FNDC - PROPOSED DISTRICT PLAN

COASTAL ENVIRONMENT, NATURAL CHARACTER & OUTSTANDING NATURAL LANDSCAPES

FOR: FAR NORTH DISTRICT COUNCIL

5 July 2024

Figure 1 Proposed Maori Purpose Rural Settlement zone taken from p12 of the submission

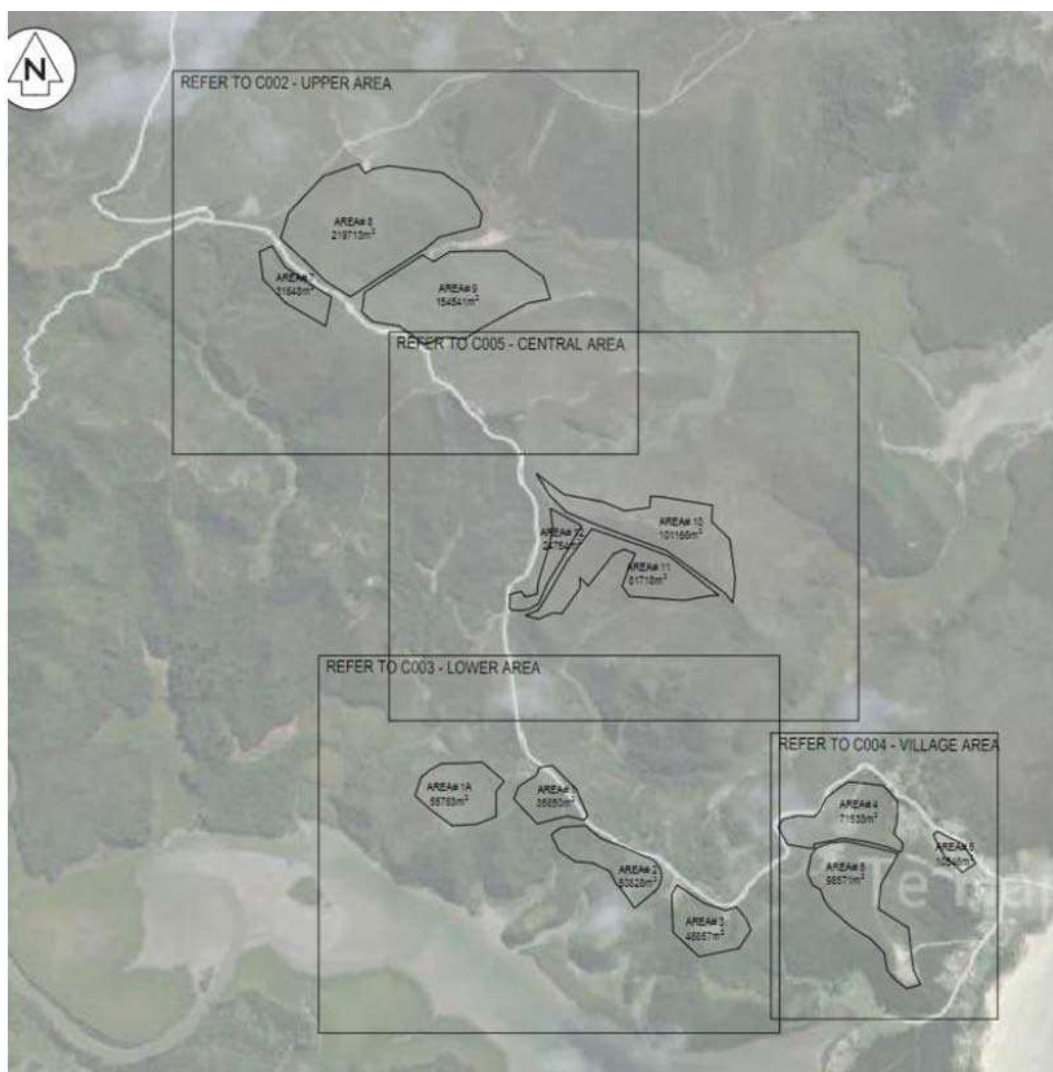
Specifically, in s420.007 they seek removal of the ONL overlay from that part of their land that they propose be re-zoned Māori Purposes Rural Settlement zone, illustrated in **Figure 1** below. Having carefully reviewed the PDP maps relating to Te Hāpua, I can confirm that there are no ONLs over the area illustrated.

Figure 2 Excerpt from PDP maps with ONL overlay over aerial photography. The forestry areas referred to above are highlighted in blue

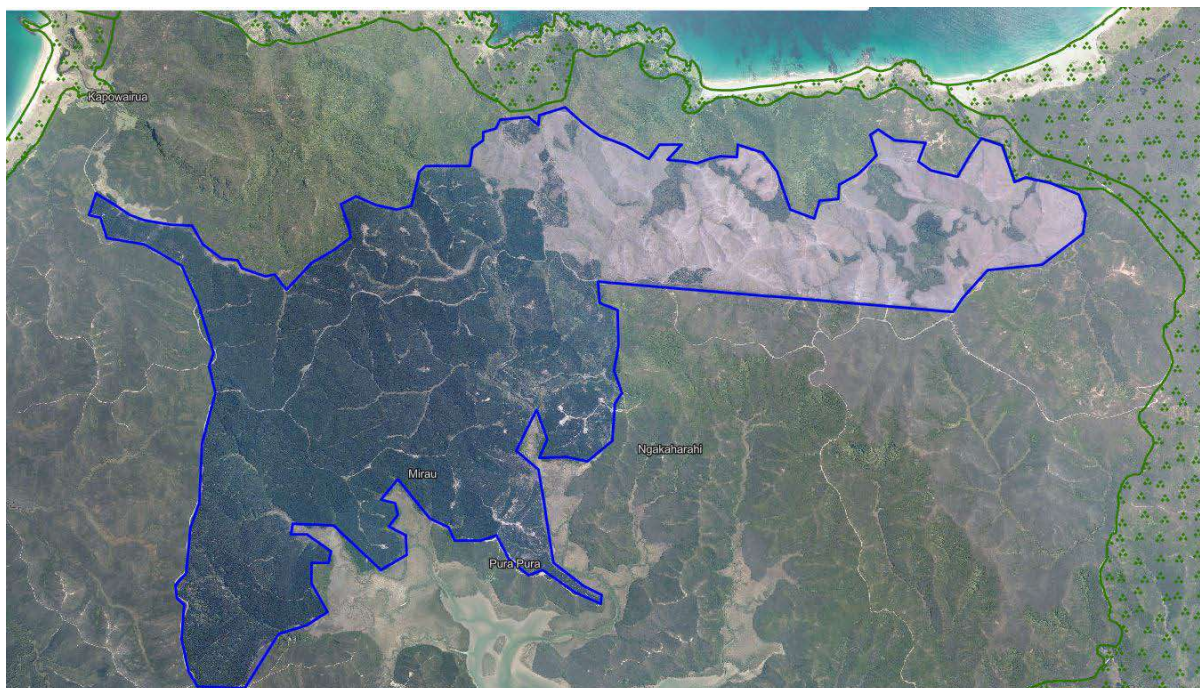
Submission point s420.009 seeks the removal of the ONL "from that part of the Te Hāpua and Shenwood Forests that is greater than 500m from the coast." Although not defined in the submission, the areas of forestry referred to would appear to be those lying immediately east of Spirits Bay Road, as illustrated in the polygon in **Figure 2** below.

As can be seen, there is no ONL overlay over the areas of forestry.

Figure 3 Area Matauri Trustee Limited requests be removed from the CE

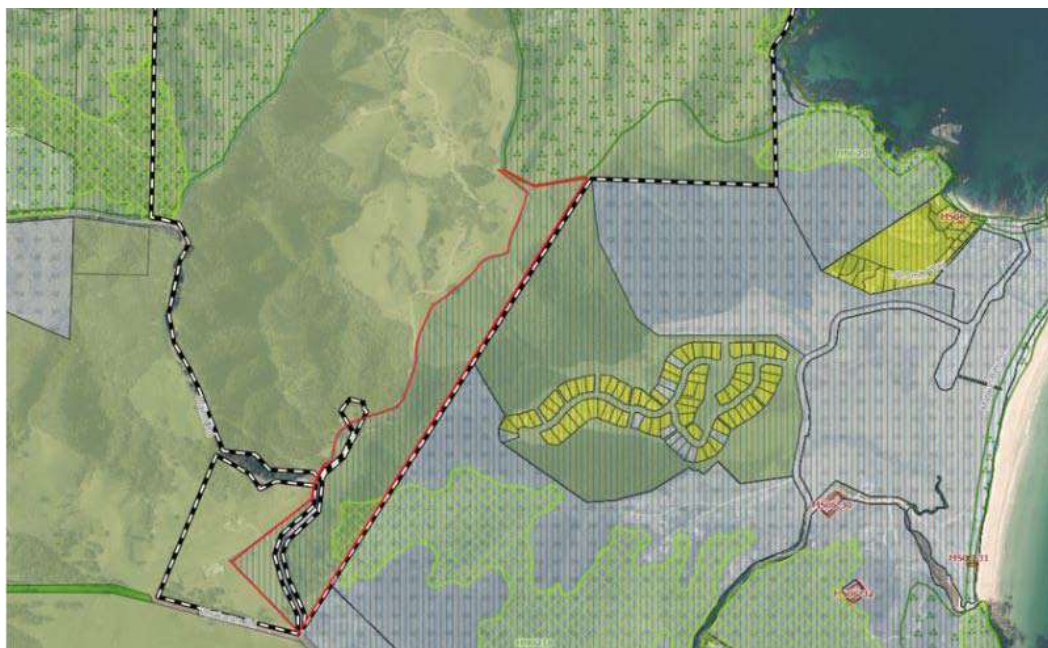
This submitter seeks that the CE overlay on part of their property be removed. The map **Figure 3**, below, shows the area where they seek the CE overlay removed outlined in red:

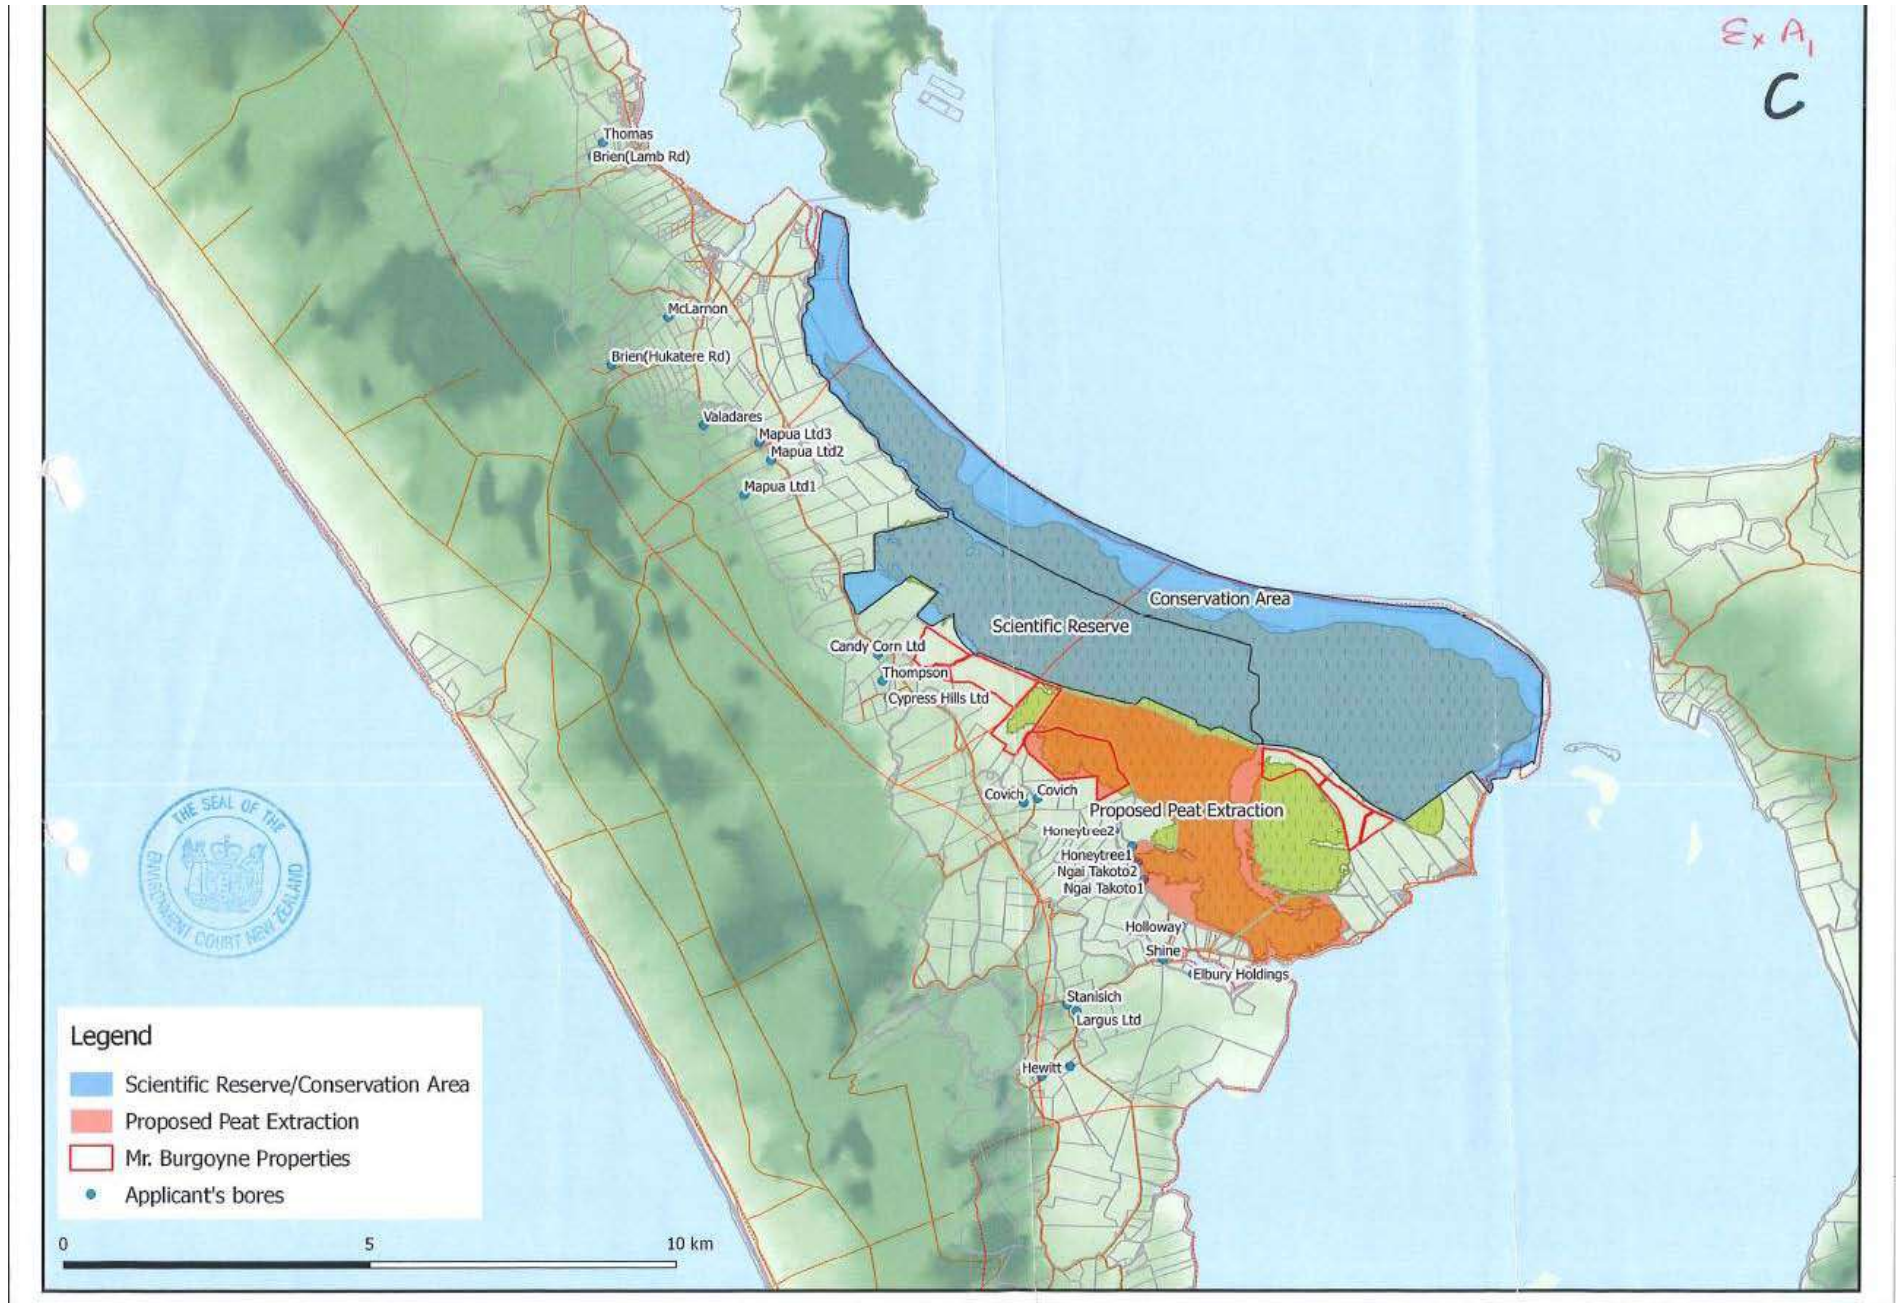
The Map B referred to in the decision is included overleaf. The key on the map shows that the topography of the wetland in metres above sea level is illustrated in bands of colour.

The landward edge of the CE as mapped in the RPS and PDP appears, from aerial photography, to follow a change in vegetation type or height and sits more or less consistently at about 1km from the coastal edge.

Although the Environment Court decision is somewhat ambiguous about which bands of colour in Map B it is referring to, it nevertheless concludes that both the Scientific Reserve and Conservation Area (together called the Reserve Area) is within the CE. I have also included Map C from the Environment Court decision, as this more clearly identifies the boundaries of the Scientific Reserve and the Conservation Area.

Figure 4

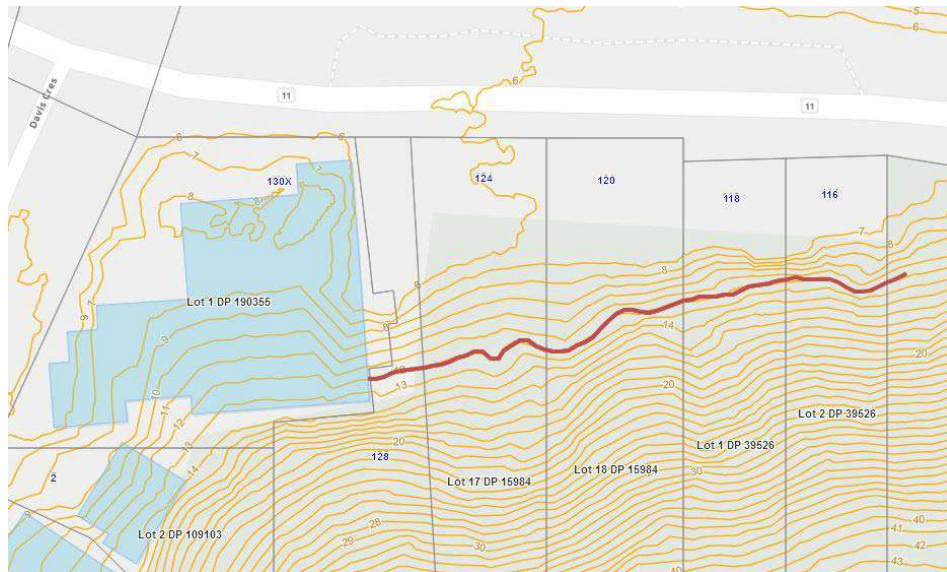
As can be seen from the two maps overleaf, the edge of HNC 426 does not extend down to the bottom of the coastal escarpment but leaves the bottom vegetated slopes free of the overlay.

Figure 4 below shows the site and 12m contour in red, as shown in the FNDC property and land maps.

Figure 7 *Is the new building 'higher' than the ridgeline or not?*

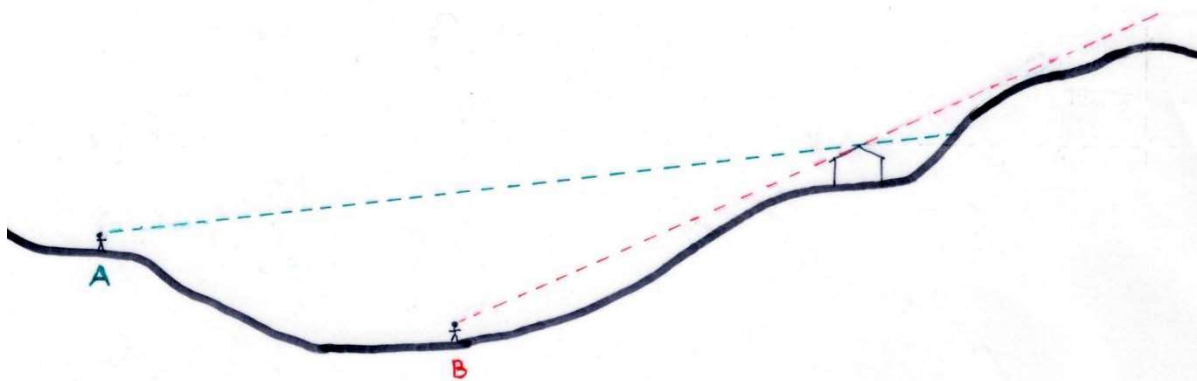
In example b. above, although the actual height of the structure may be appropriate in relation to local landform features, the specific location of a viewer, in relation to these two features, will be determinative in whether the building "appears" higher than the particular landform or not. I include **Figure 7**, below to illustrate what I mean.

The farm shed in **Figure 7** above has been constructed so that the highest point is below the crest of the nearest ridge. For viewer A the ridge successfully provides a backdrop to the building. However, for Viewer B the angle of view means that the building has no backdrop provided by the ridge and may appear on the skyline 'above' the ridge.
